DJR Operating LLC requests permission to P&A the subject well per the attached procedure, current and proposed wellbore diagram.

PLUG AND ABANDONMENT PROCEDURE

Central Bisti Unit #48

Re: Permanent Abandonment
Well: Central Bisti Unit 48

CBU #48 Proposed P&A

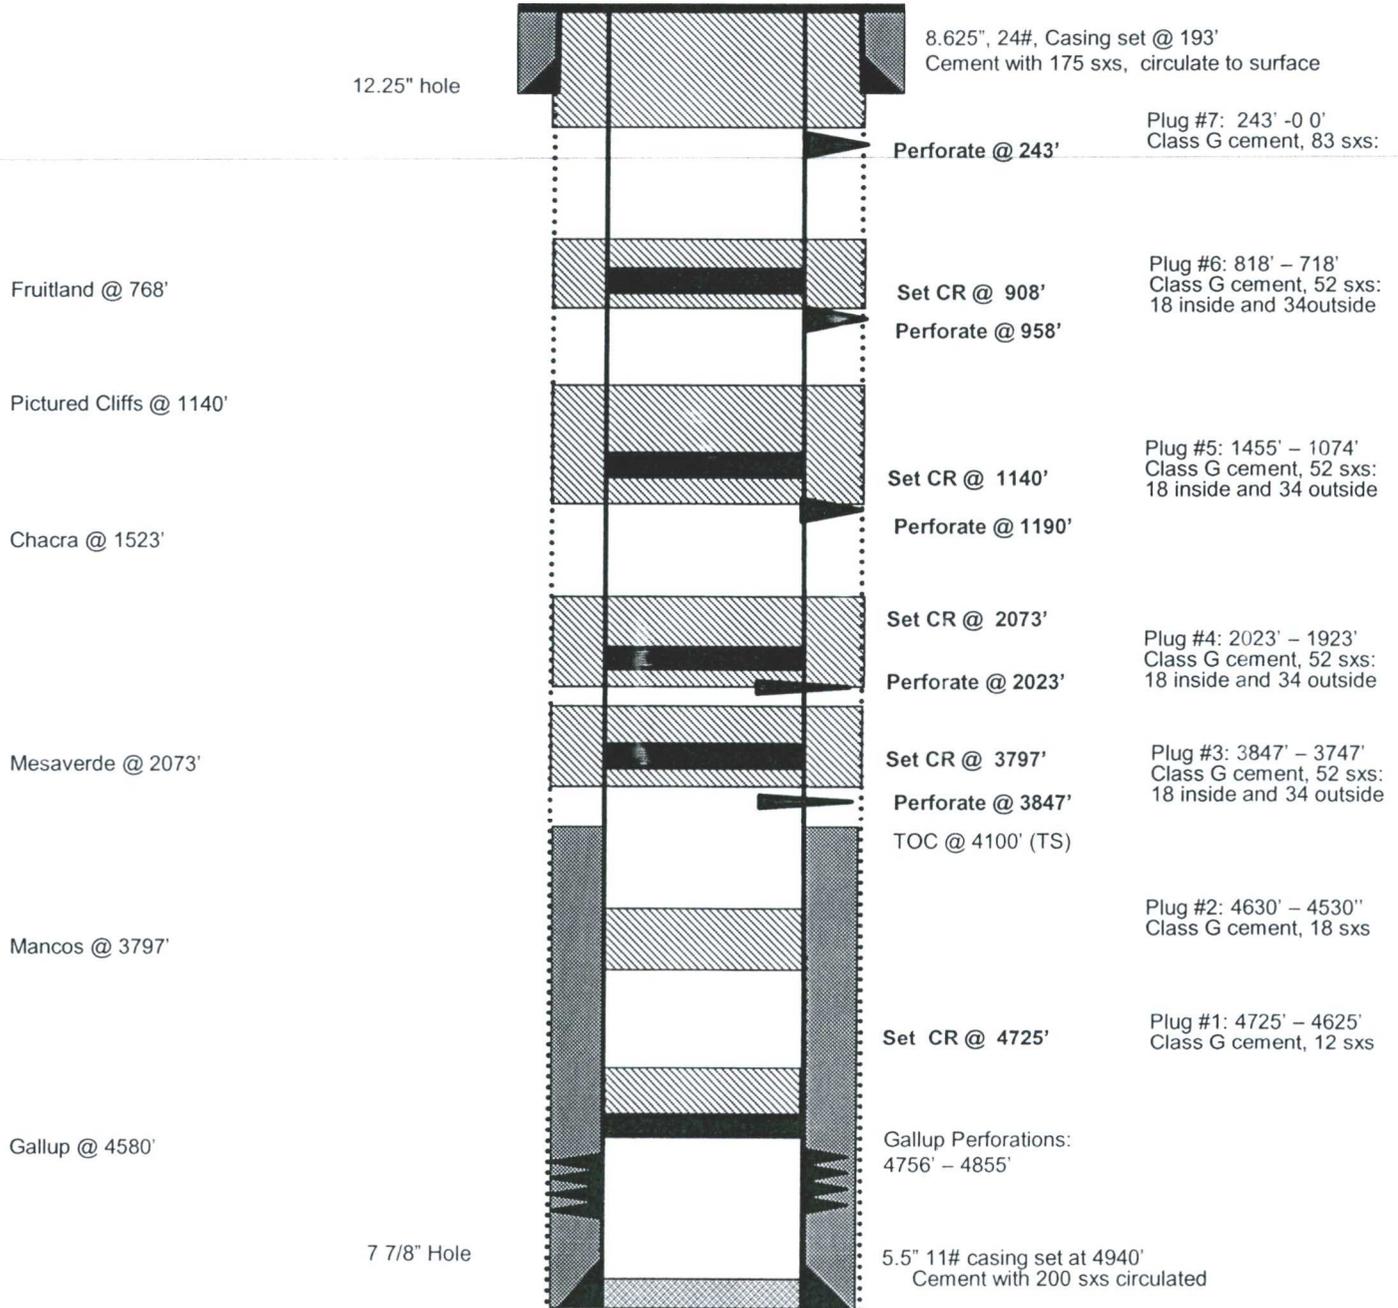
- Notify NMOCD 24hrs prior to beginning operations.
- Add a plug from 1573' - 1473' inside/outside to cover the Chacra top.

3. The following modifications to your plugging program are to be made:
 - a) Set Plug #3 (3970 - 3690) ft. inside/outside to cover the Mancos top. BLM picks top of Mancos at 3740 ft.

- b) Set Plug #4 (1951 - 1851) ft. inside/outside to cover the Mesaverde top. BLM picks top of Mesaverde at 1901 ft.
 - c) Set Plug #5 (1210 – 1110) ft. inside/outside to cover the Pictured Cliffs top. BLM picks top of the Pictured Cliffs at 1160 ft.

- d) Set Plug #6 (887 – 787) ft. inside/outside to cover the Fruitland top. BLM picks top of Fruitland at 837 ft.
 - e) Set Plug #7 (260 – 0) ft. inside/outside to cover the Kirtland top. BLM picks top of Kirtland at 210 ft.
